RE: Rochester Housing Authority,  
**Unit Renovations-Parkside**

**ADDENDUM #1**

ROCHESTER HOUSING AUTHORITY  
PARKSIDE APARTMENTS  
PHASE II: UNIT RENOVATIONS

**AB102**

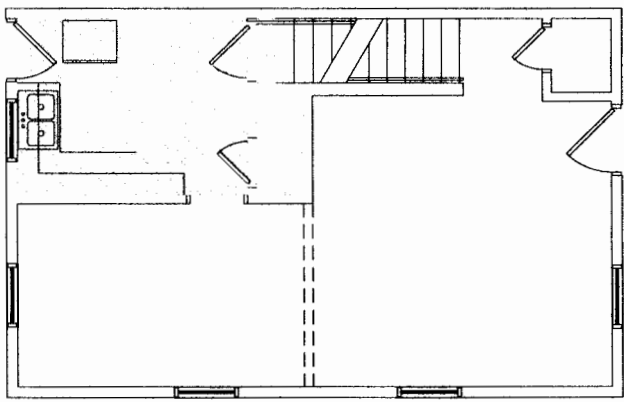
Add Drawing AB 102, Abatement Drawing Addendum 1

This drawing is a typical representation of the first floor of a second style of 3 bedroom apartment. The drawings shows asbestos abatement limits.
